ADDENDUM #3

PROJECT: Rapid Valley Elementary School Addition and Remodel
DATE: March 16, 2026
BID DATE: March 19, 2026 at 2:00pm MST

PROJECT ADDENDUM NO. 03

ADDENDUM NO. 3 - MECHANICAL

PROJECT NO: 2521
A202

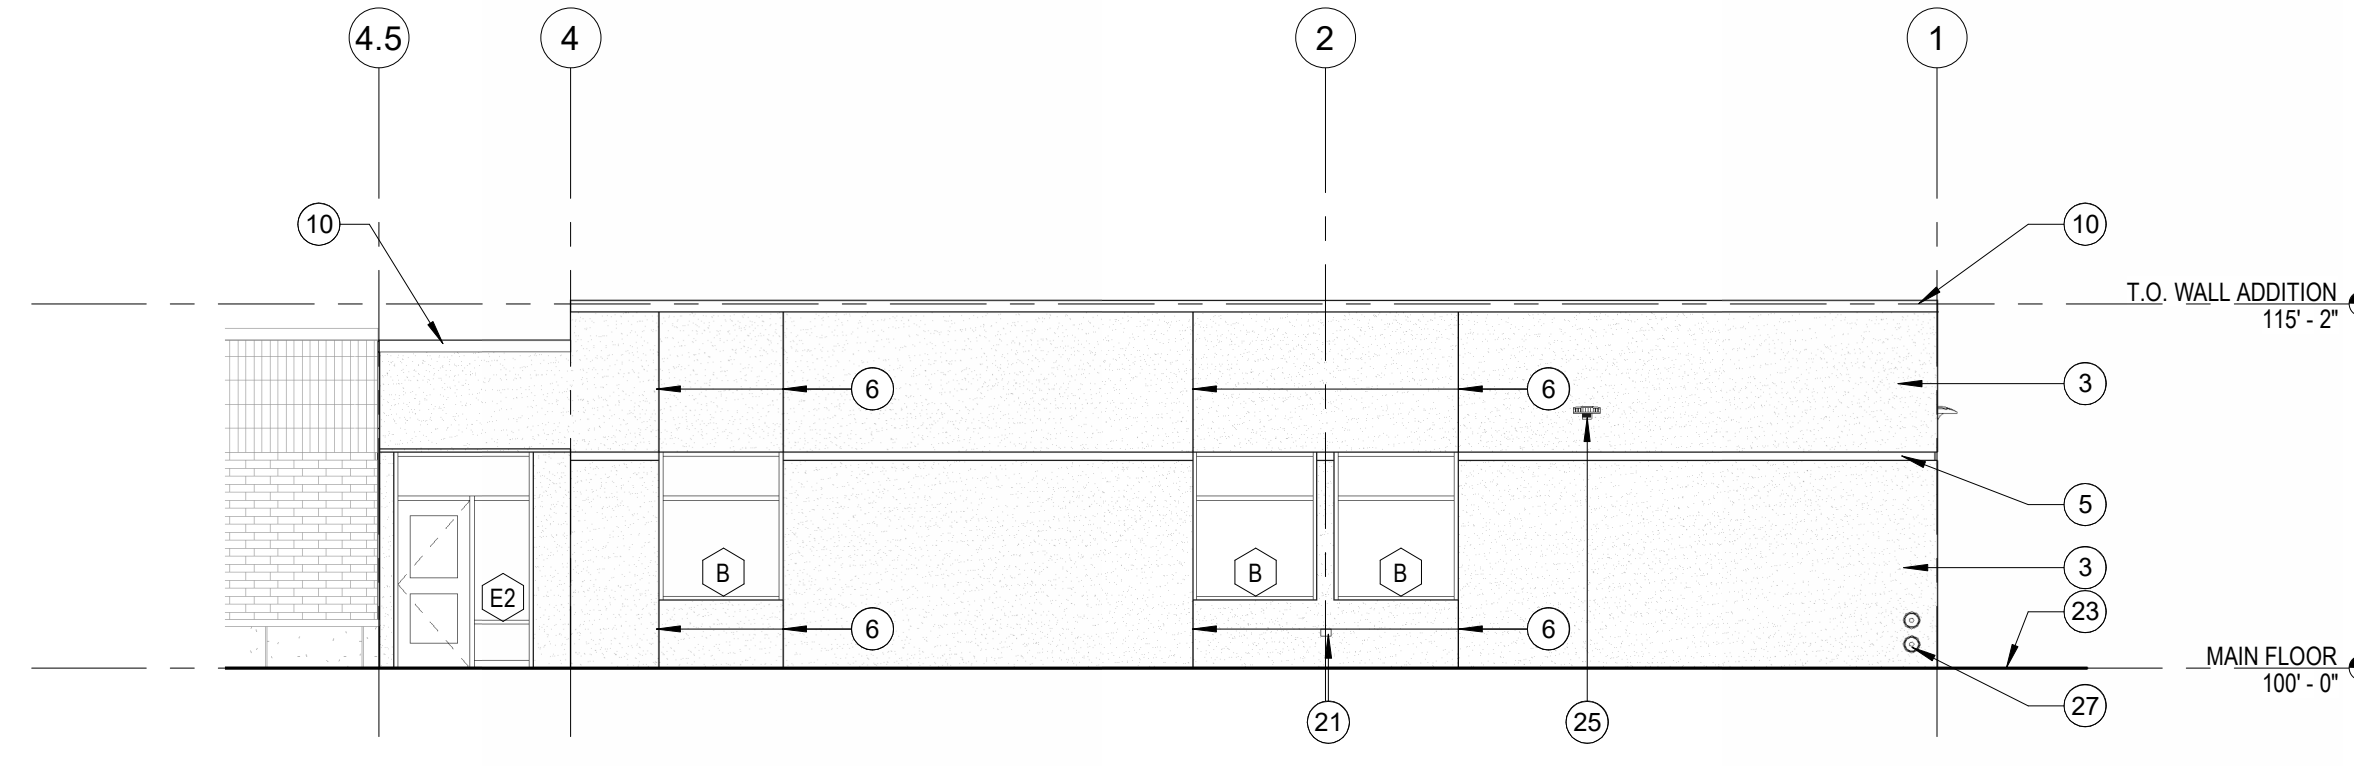
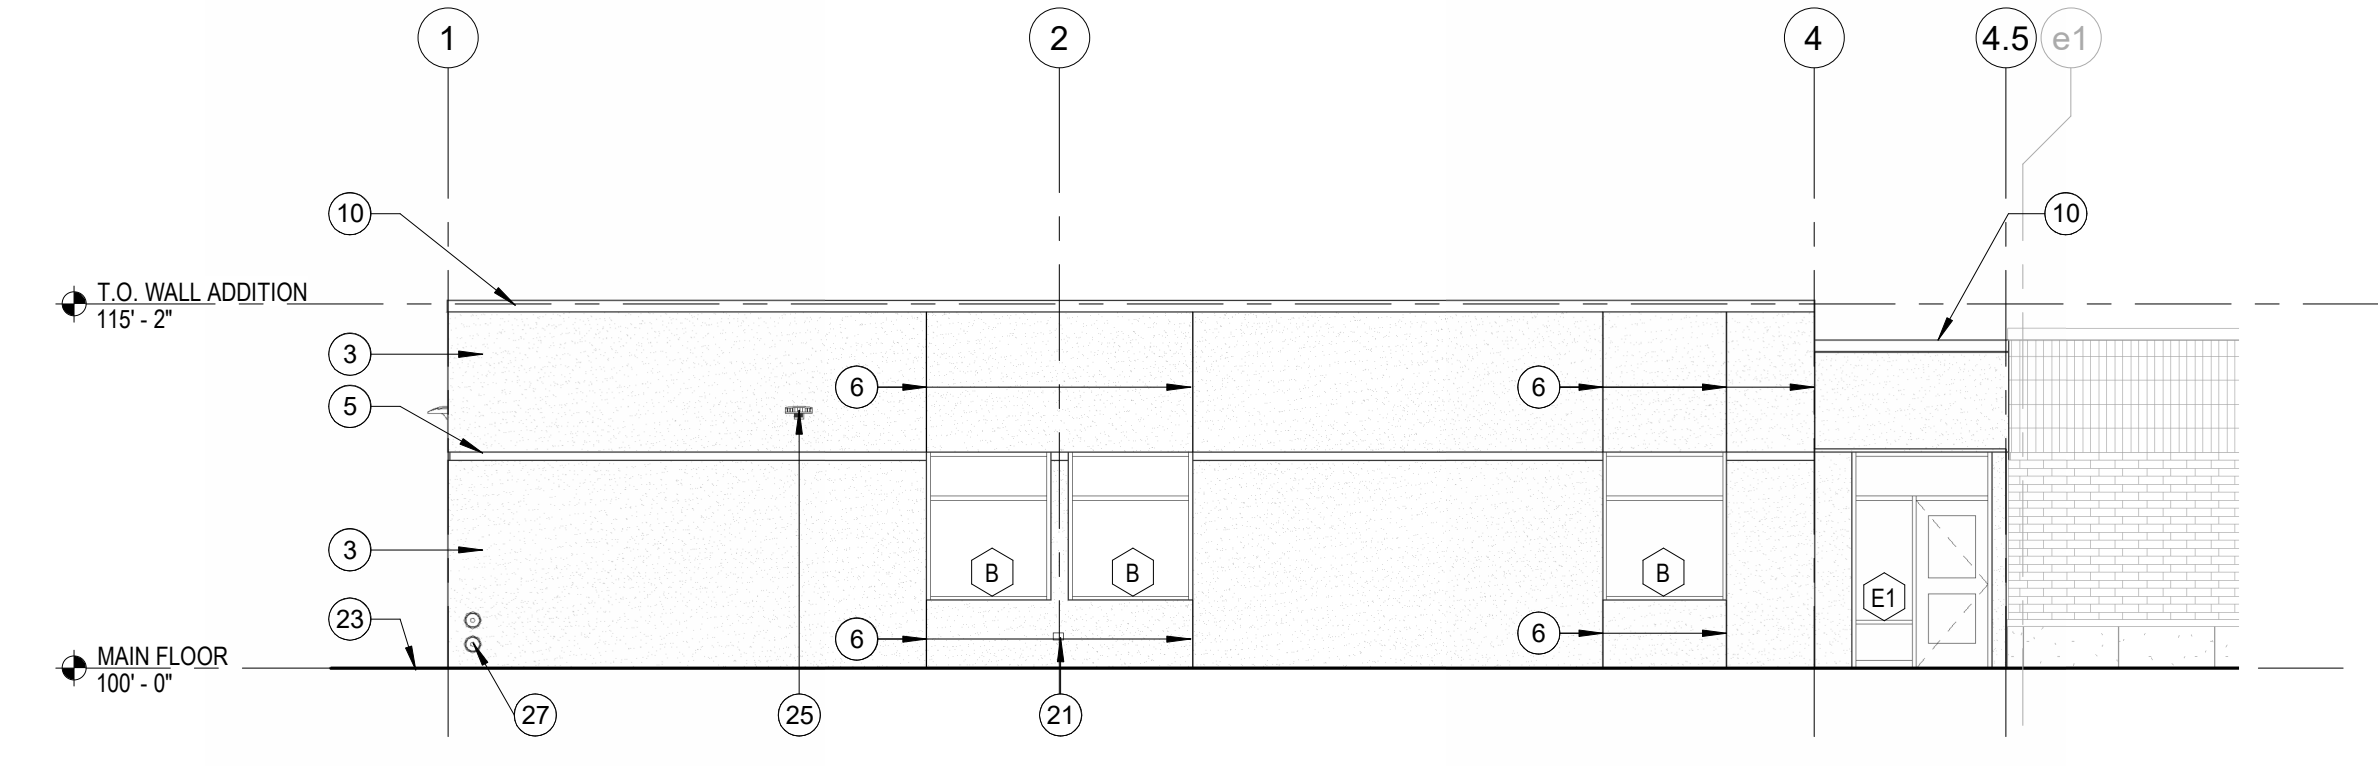
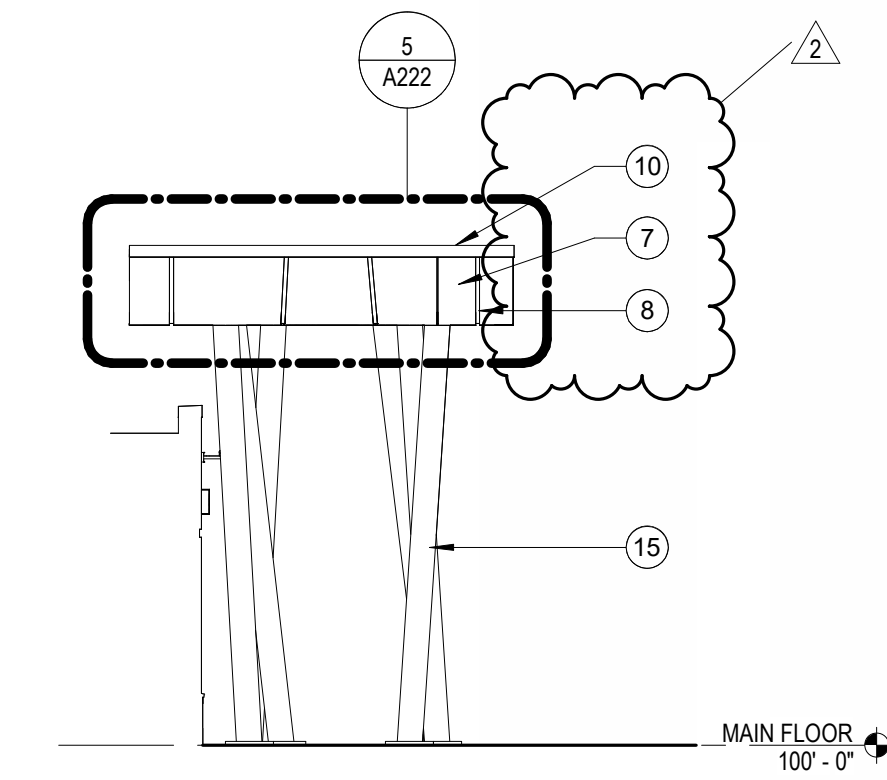
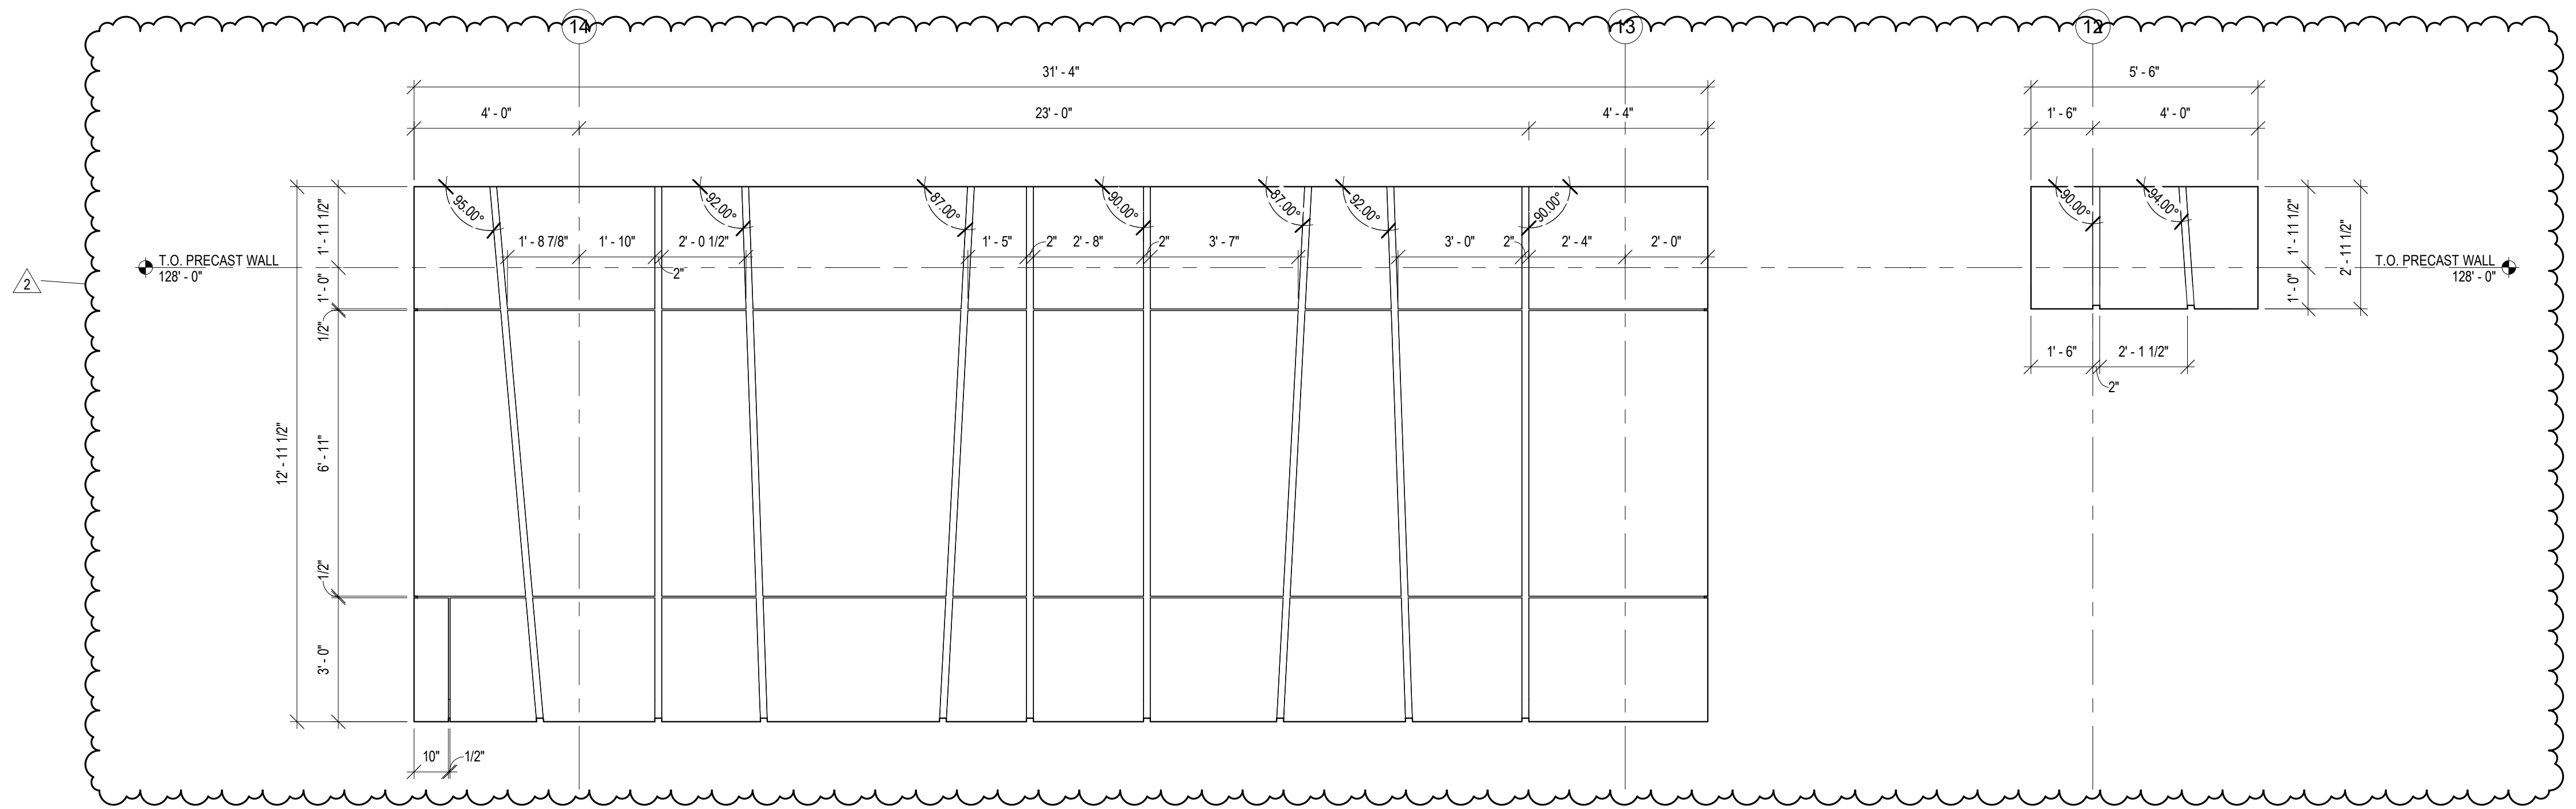
ADD 3-11 A202 – EXTERIOR ELEVATIONS
 1. Revise elevations for parapet copying.
